Nipa Knitwear Company

Selina Tower-04: Islambag, Holan Road, Dhakhin khan, Dhaka-1230

18th February 2015

Observations

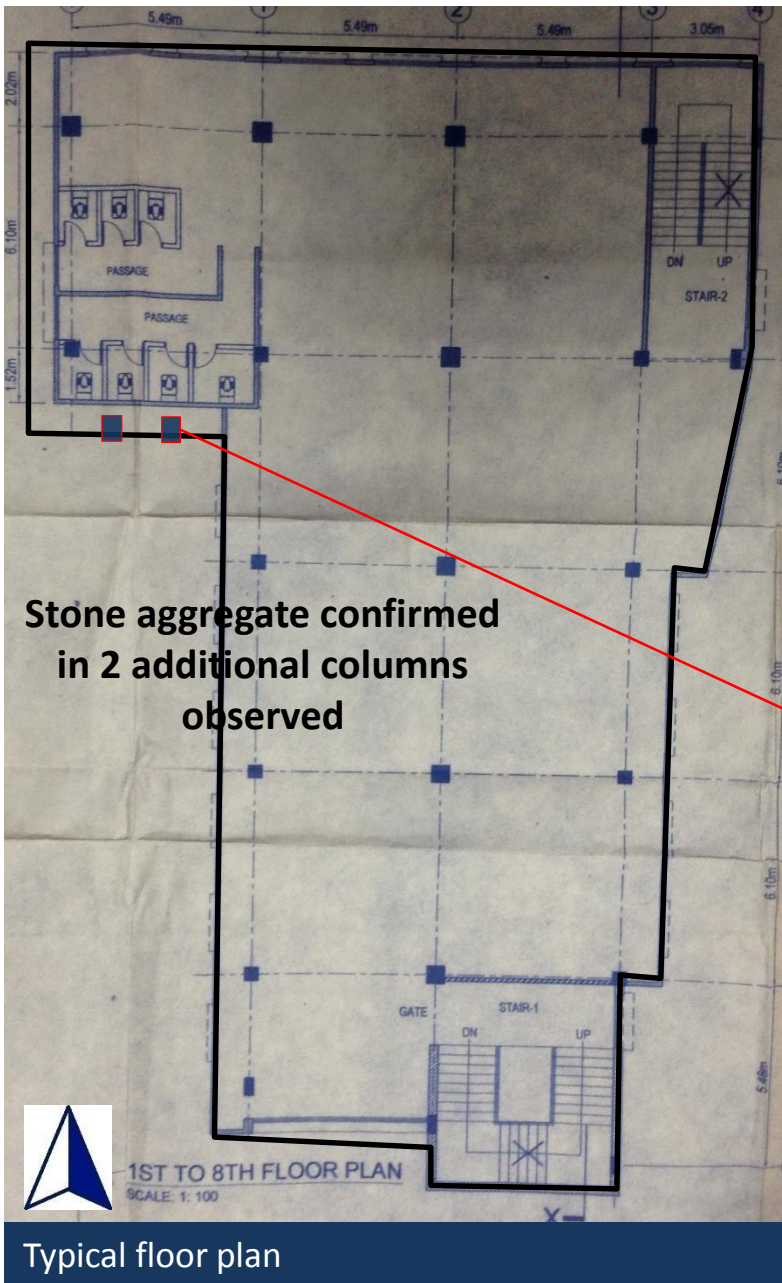
High stress levels in perimeter columns carrying cantilevers

Cursory calculation indicate that the working stress of some perimeter columns are at a high level mainly due to the load of the walls, some build-ups and the cantilever.

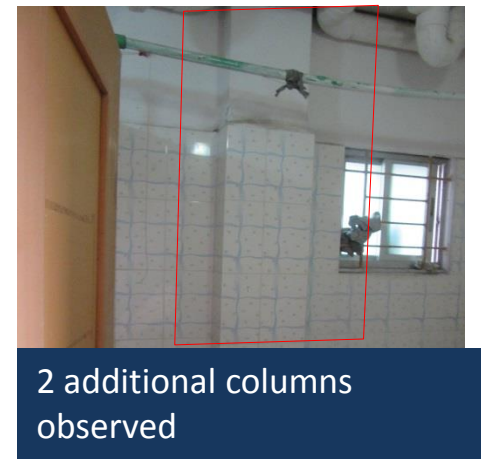
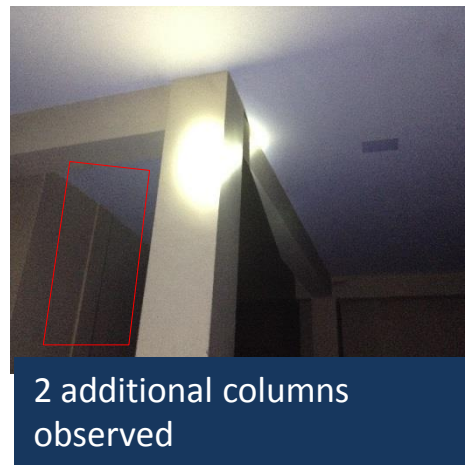
Discrepancies between the permit drawing and the as-built structure

Stone aggregate confirmed
in 2 additional columns
observed

Staircase

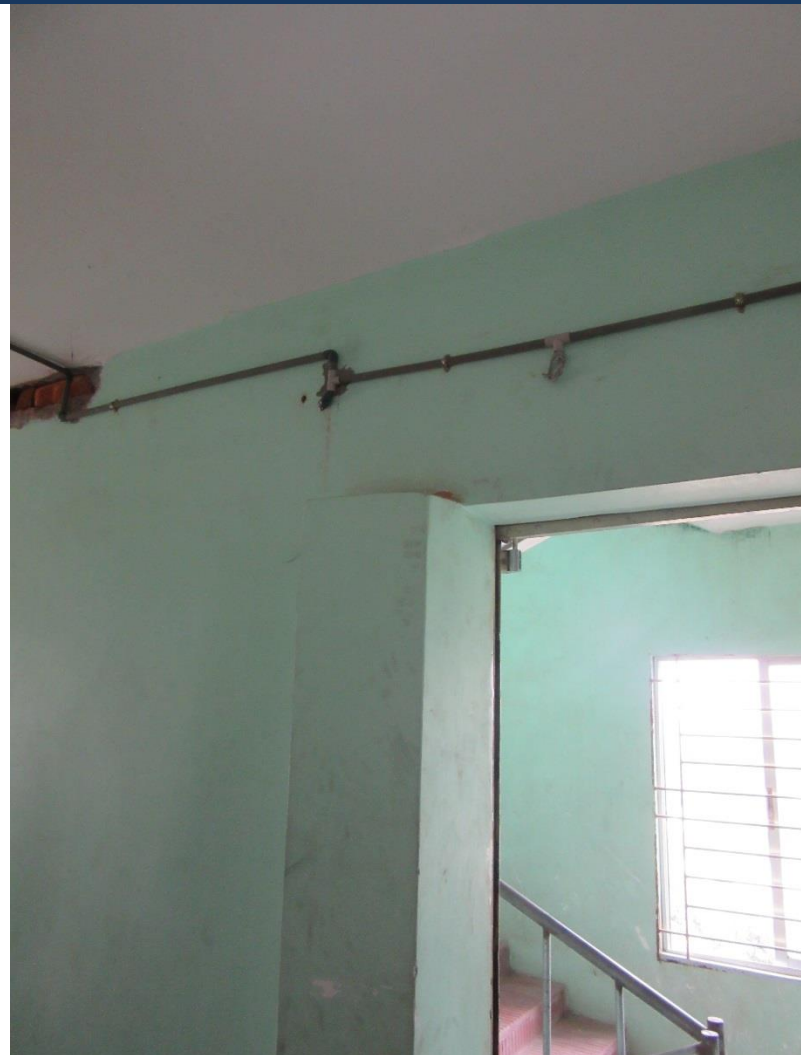
Structural elements which are not shown on the original design drawings

Column on the 4th floor

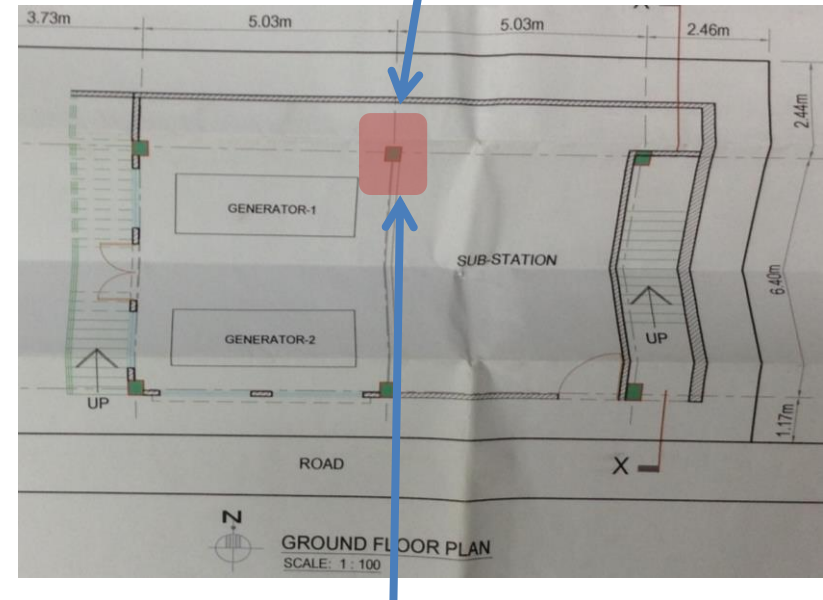
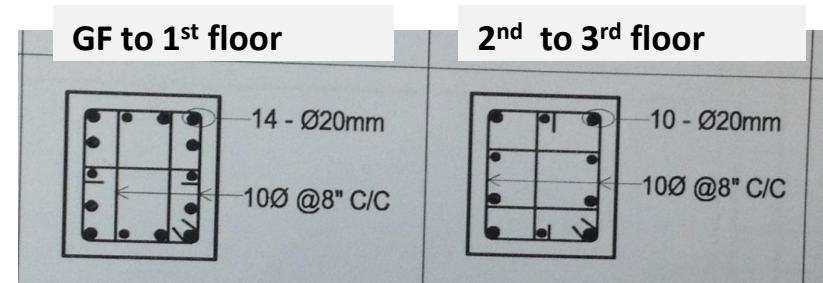
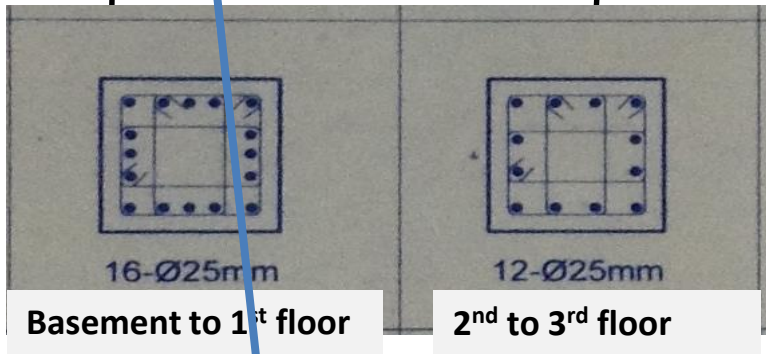
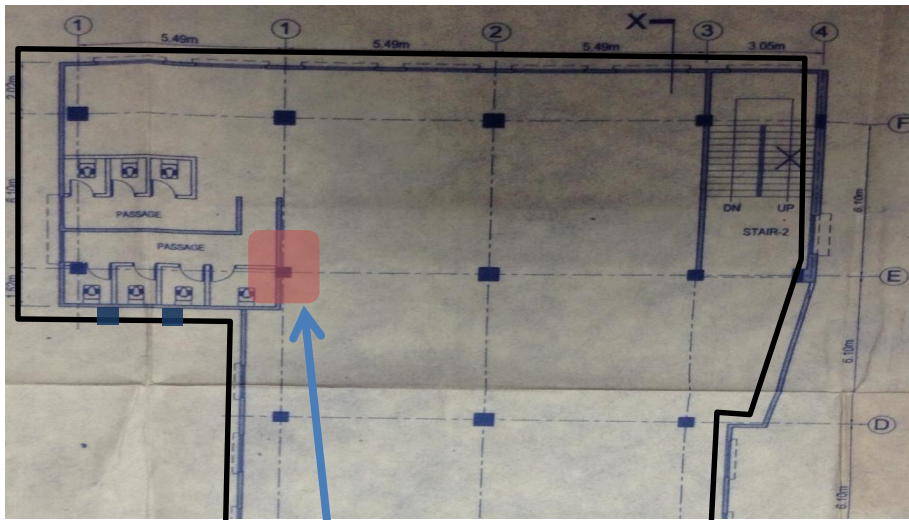
- Production Building Basement: 4 rebar bars were found on both sides for a total of 12 bars. However, structural drawing shows 16 bars at this level.

- Generator House 1st floor: 4 bars were found on each side for total of 12 bars. However, structural drawing shows 14 bars at GF level.

Production Building – Typical floor plan

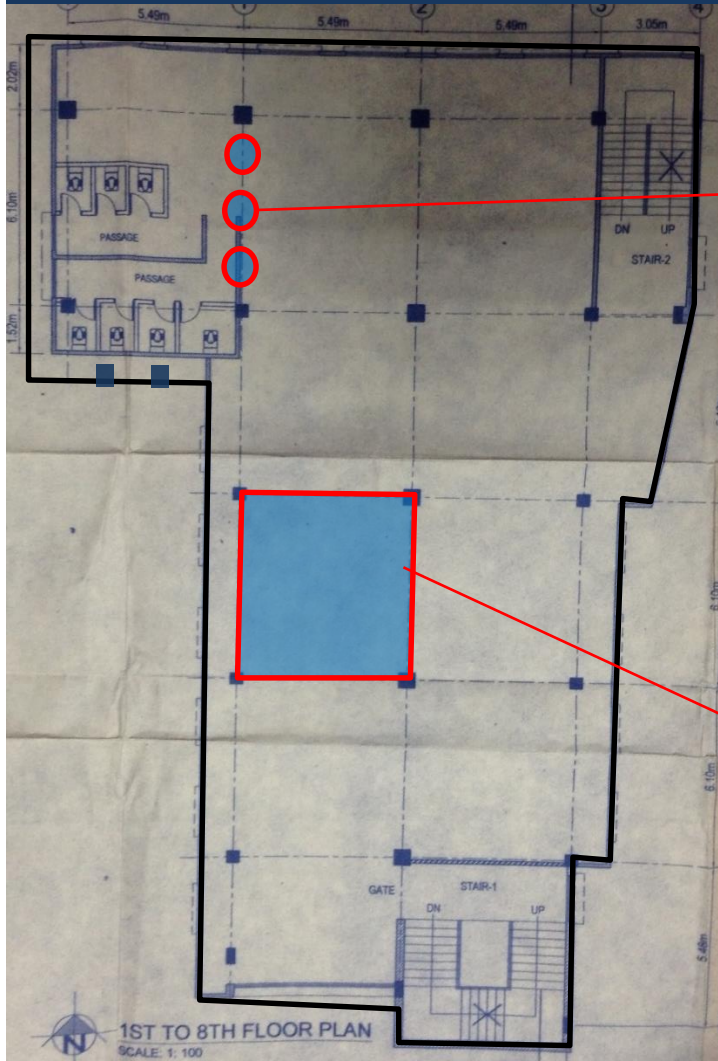
Heavy loading from water tanks

3 Water tanks on roof – 5000 litres each (total 1500 kN)

14	Uncontrolled storage and heavy loading – Production Building and Generator House	Spread the load of the roof water tanks on a bigger area.	6-weeks
15	Uncontrolled storage and heavy loading – Production Building and Generator House	Building Engineer to continue to implement loading plan.	6-months
16	Apparently non-engineered lightweight steel stair structures in Generator House	Building Engineer to assess adequacy of the lightweight steel stairs to withstand code vertical and wind loads, including connections to the Generator House.	6-months
17	Apparently non-engineered lightweight steel stair structures in Generator House	Carry out reconstruction or remedial works arising from the assessment.	6-months

Water tank on 8th floor

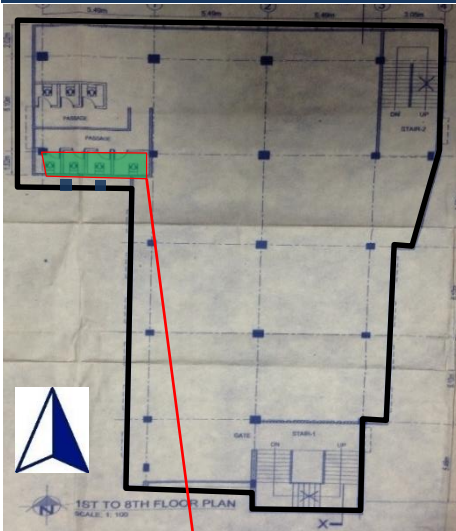
Tank is not a full floor height, so it has an additional slab. Dimension 3.05m x 2.75m x 1.75m.

8th floor plan

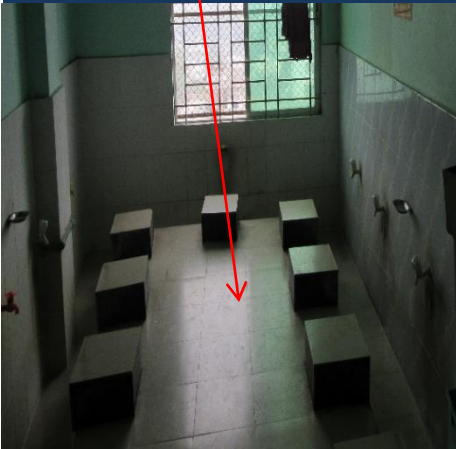
Toilet build-up

Build-ups 250mm

2nd, 4th, 5th, 6th, 7th floor

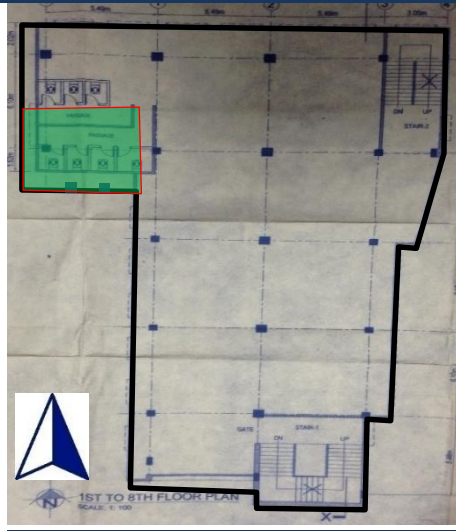
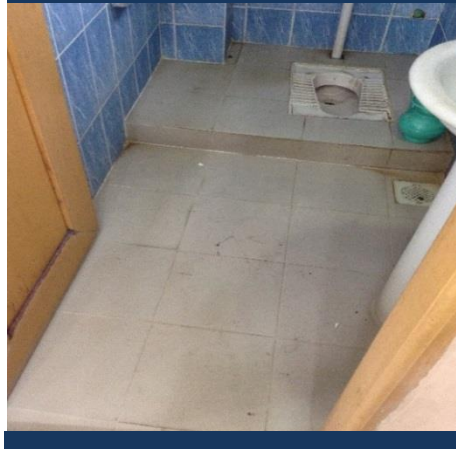
150 mm build up on every floor

Ground and 1st floor loaded area

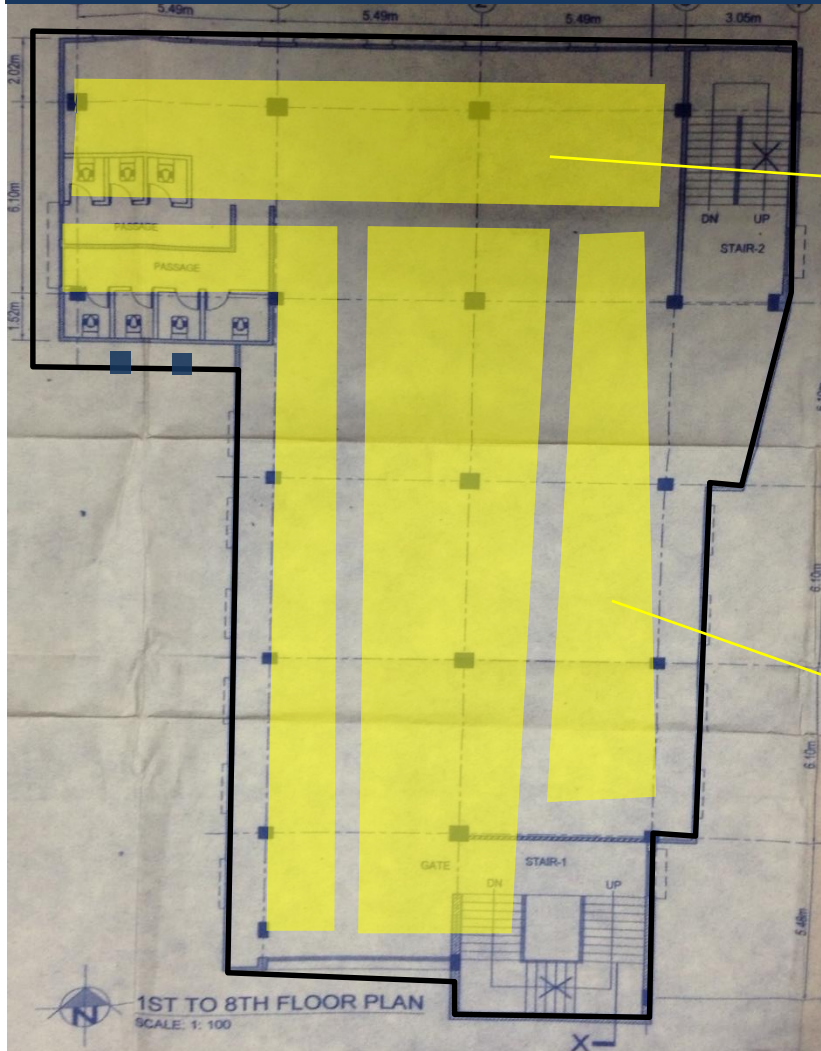
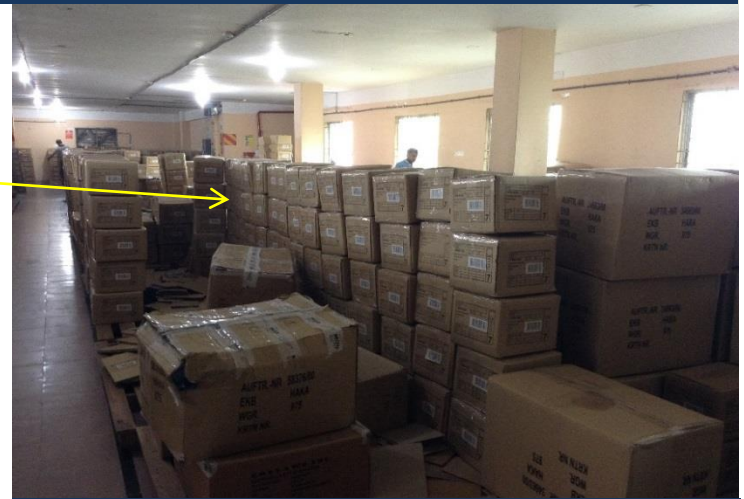
Heavily-loaded storage

1.5m high boxes on entire 1st floor

1.3m high fabric roll on entire ground floor

Heavy loaded areas on the 1st floor (Gen. house)

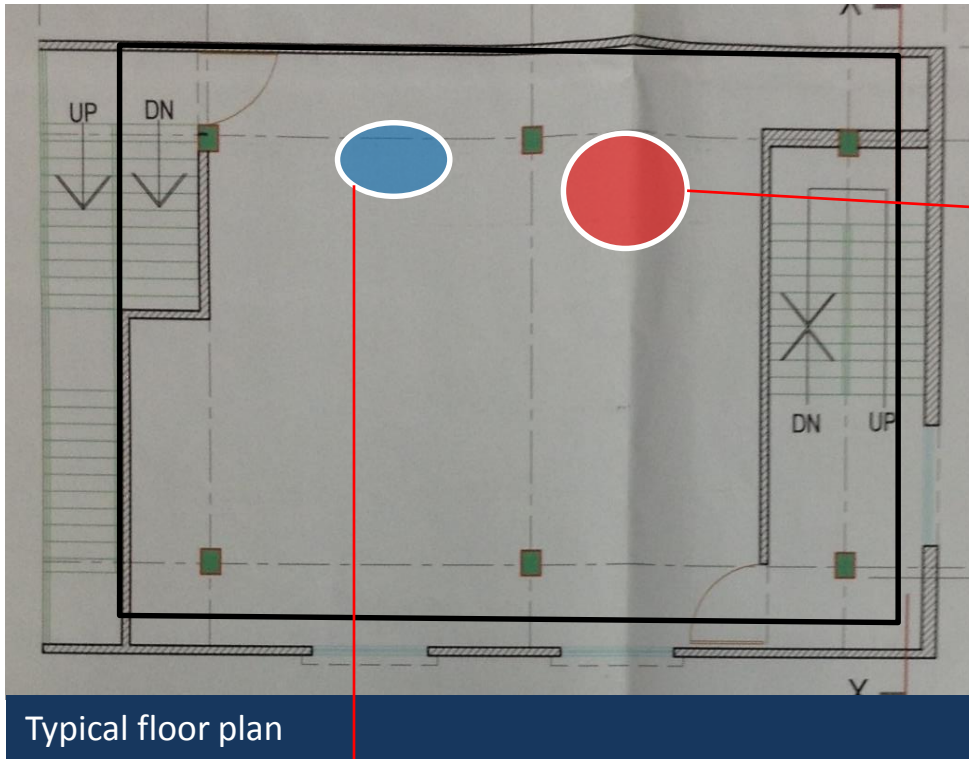
40-50KN boiler on 1st floor

500L water tank on 1st floor

Typical floor plan

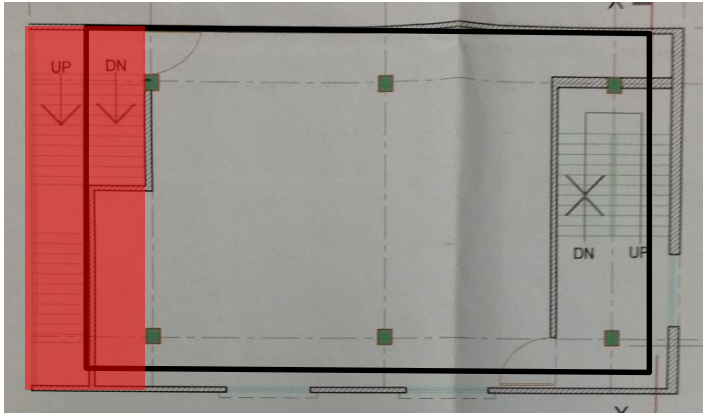
Heavily-loaded uncontrolled storage

1.3m high fabric roll on 2nd and 3rd floor

2m high lightweight storage on 4th and 5th floors

Non-engineered steel stair structure

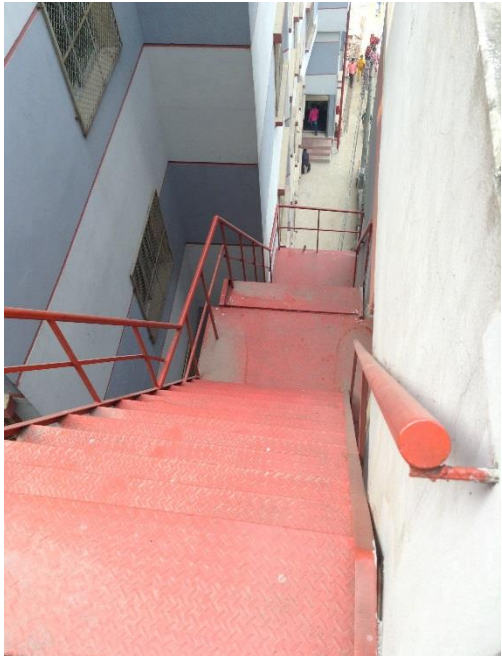
Apparently non-engineered lightweight steel stair structures
